Access Compliance Report Public Rights-of-Way (Curb Ramps)

Main Street: DODGE_AVE Cross Street: HEWES_AVE Location: SE

ADA ID: RPAT211015085913 Ramp Type: Type 4 - Parallel Initial Pass/Fail: Fail Overall Compliance: No Severity Score: 20

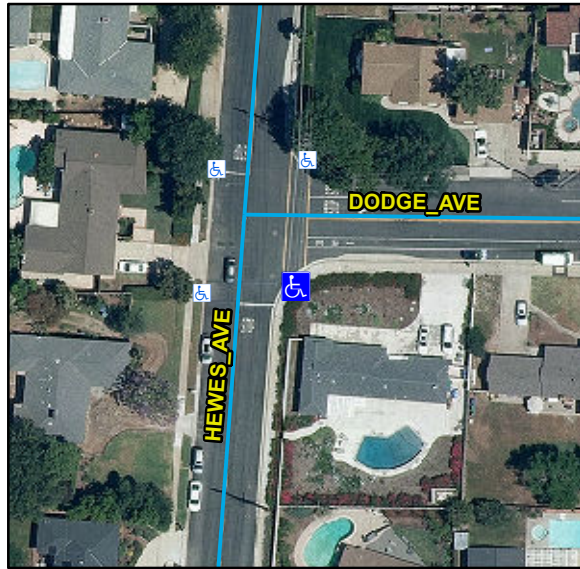
Compliance	Description	Data	Compliance	Description	Data
N/A	Ramp Length LT (in)	88	N/A	Ramp Length RT (in)	70
Yes	Ramp Width LT (in)	53	No	Ramp Width RT (in)	43
No	Ramp Run Slope LT (%)	9	Yes	Ramp Run Slope RT (%)	5.8
Yes	Ramp Cross Slope LT (%)	2	Yes	Ramp Cross Slope RT (%)	0.7
N/A	Landing Present	N/A	N/A	DWS Provided	N/A
N/A	Landing Length (in)	N/A	N/A	DWS Contrast	N/A
N/A	Landing Width (in)	N/A	N/A	DWS Length (in)	N/A
N/A	Landing Run Slope (%)	N/A	N/A	DWS Full Width	N/A
N/A	Landing Cross Slope (%)	N/A		DWS Offset Type	N/A
N/A	Landing Movement Obstructed?	N/A	N/A	DWS Offset Left (in)	N/A
	Landing Movement Type	N/A	N/A	DWS Offset Right (in)	N/A
N/A	Landing Shared	N/A			
N/A	Clear Space	Yes			
N/A	Clear Space To Crosswalk (in)	N/A			
N/A	Marked Crosswalk 1	No	N/A	Marked Crosswalk 2	No
	Crossing 1 Direction	N		Crossing 2 Direction	W
	Marked Crosswalk 1 Width (in)	N/A		Marked Crosswalk 2 Width (in)	N/A
N/A	Ramp Inside Crosswalk 1	N/A	N/A	Ramp Inside Crosswalk 2	N/A

Remove & Replace Curb Ramp With Two New Directional Ramps or Equivalent.
